PHILADELPHIA ELECTRIC COMPANY

January 28, 1985

Docket Nos: 50-352
50-353Mr. A. Schwencer, Chief
Licensing Branch No. 2
Division of Licensing
U.S. Nuclear Regulatory Commission
Washington, DC 20555Dr. T. E. Murley, Administrator
Region I
Office of Inspection and Enforcement
U.S. Nuclear Regulatory Commission
631 Park Avenue
King of Prussia, PA 19406SUBJECT: Limerick Generating Station, Units 1 and 2, Organizational Changes
in the PECO Electric Production Department

Attached are draft changes to FSAR Section 17.2, Figures 17.2-2, 3, 4, 5, & 15 and related 260 Series questions which describe the subject changes. These changes have been reviewed and it has been determined that the changes do not reduce the commitments in the QA Program previously approved by the NRC.

**LIMERICK MAINTENANCE GROUP
MAINTENANCE DIVISION
ELECTRIC PRODUCTION DEPARTMENT**

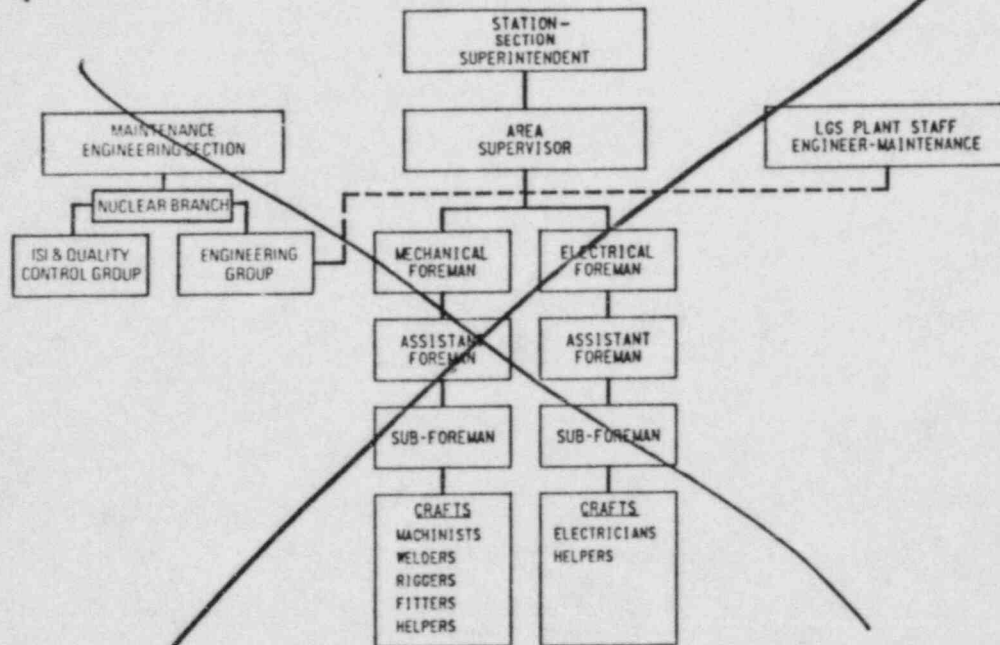
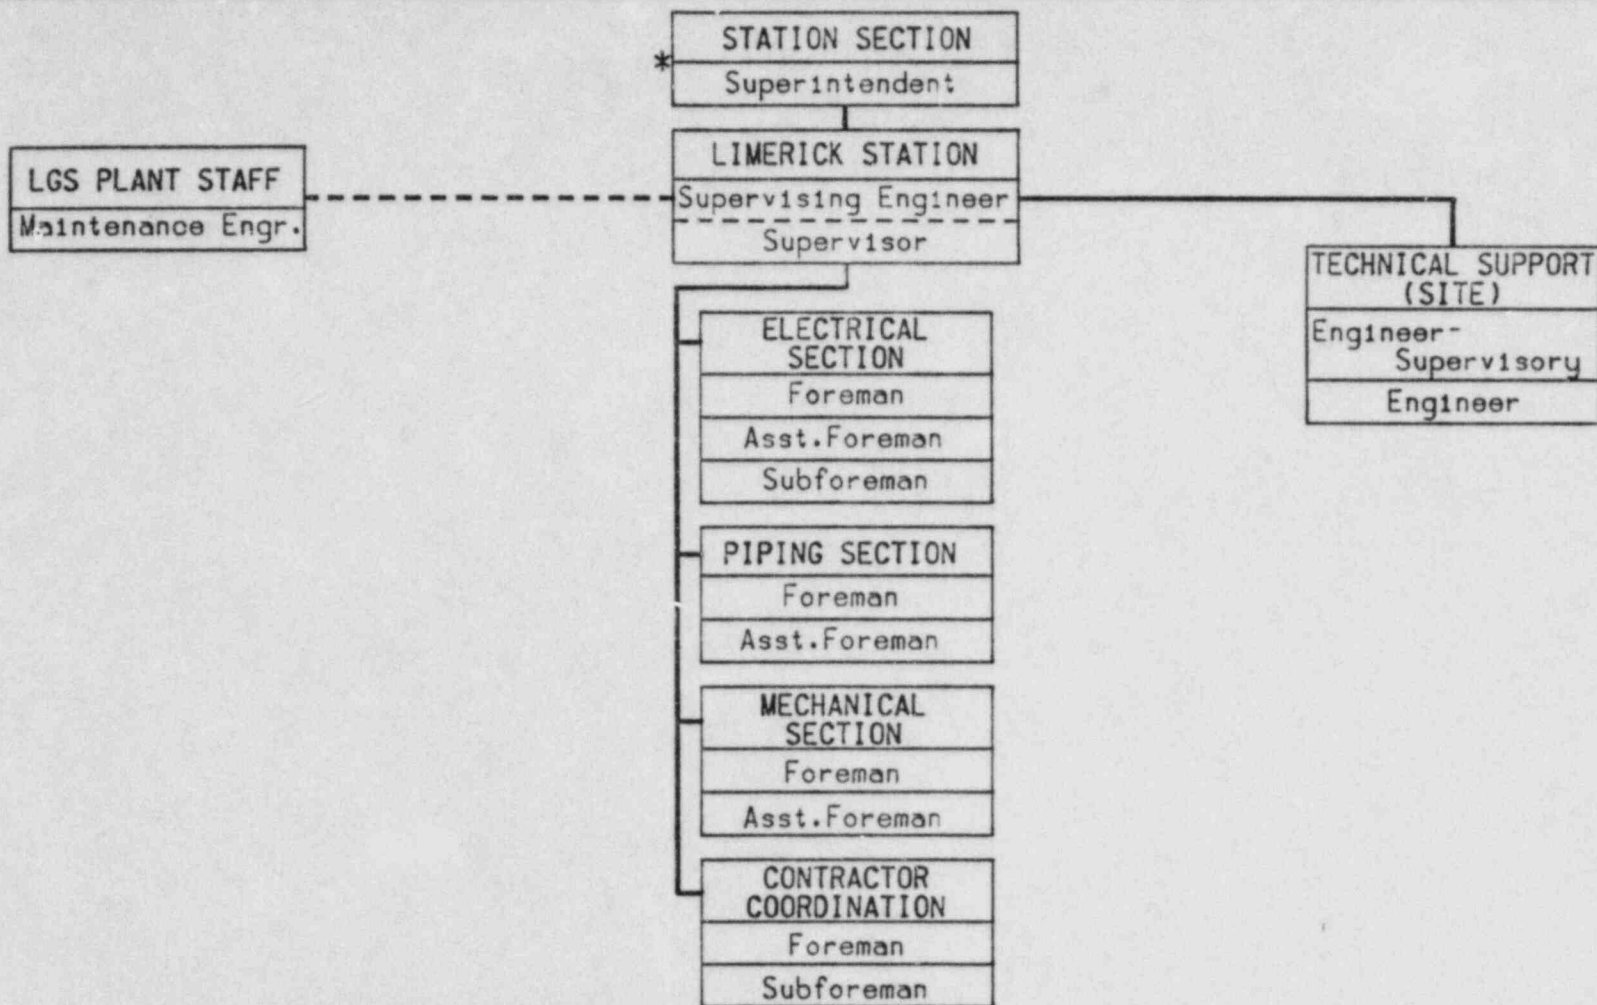
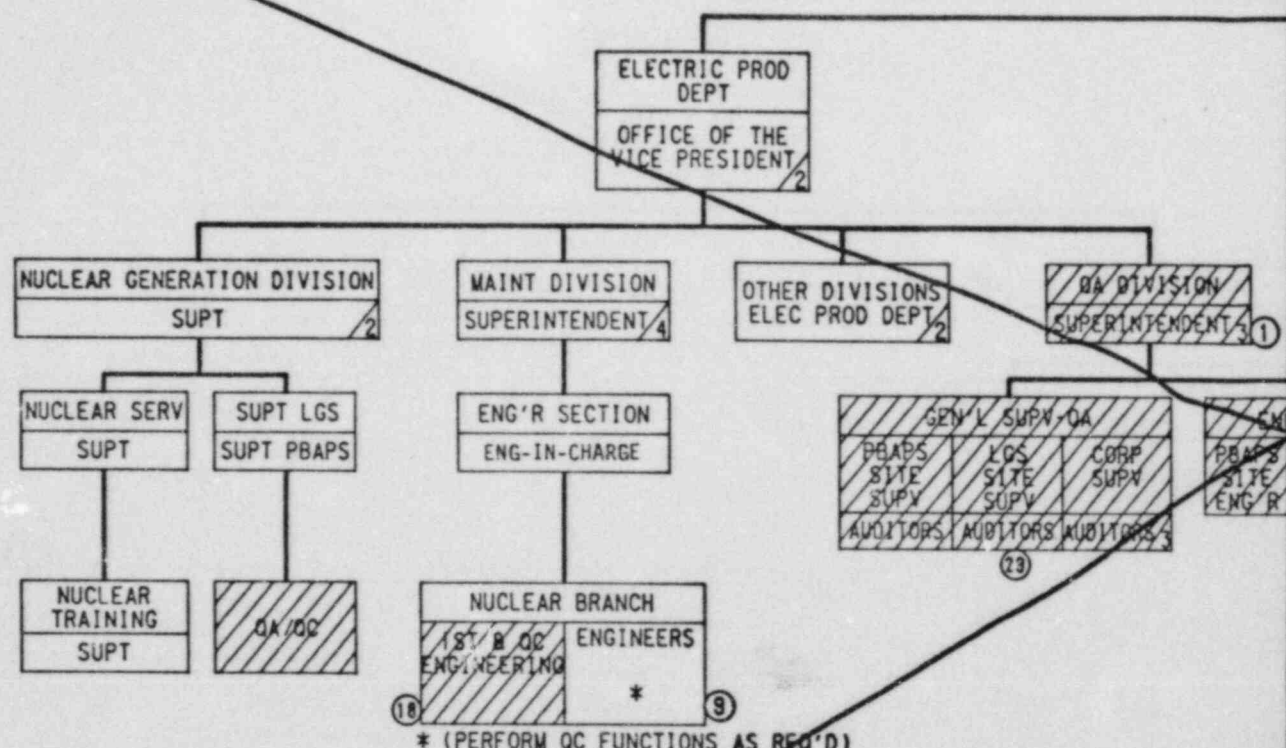
The interface between station maintenance forces, the operating staff and Maintenance headquarters is shown in Figure 17.2-5.

Insert (D)

FIGURE 17.2-15

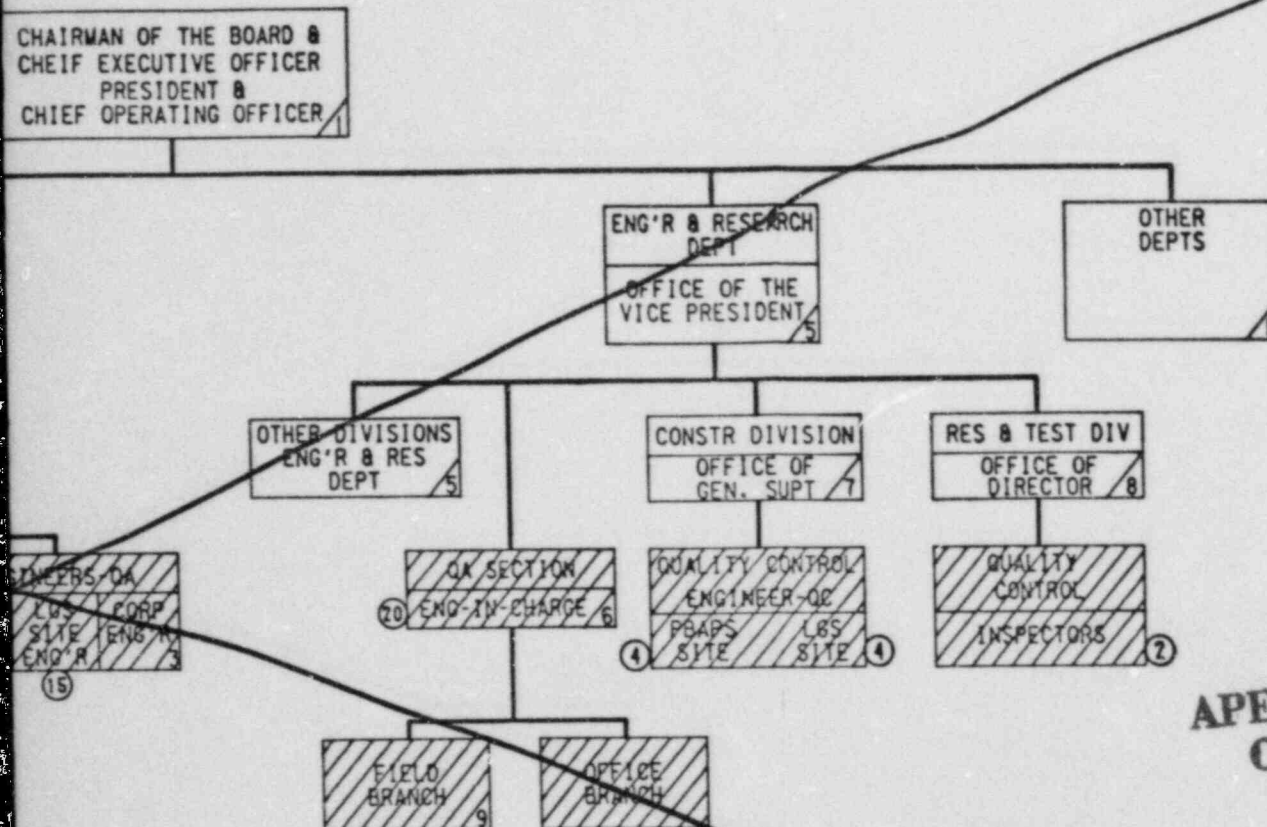
Insert (E)

Figure 17.2-15 is a functional QA/QC Diagram of organizations performing within the Electric Production Department and the Engineering and Research Department, and its

~~Figure 17.2-15~~ outlines the approximate personnel staffing for ~~QA/QC~~ organizations involved in Peach Bottom and Limerick Stations.
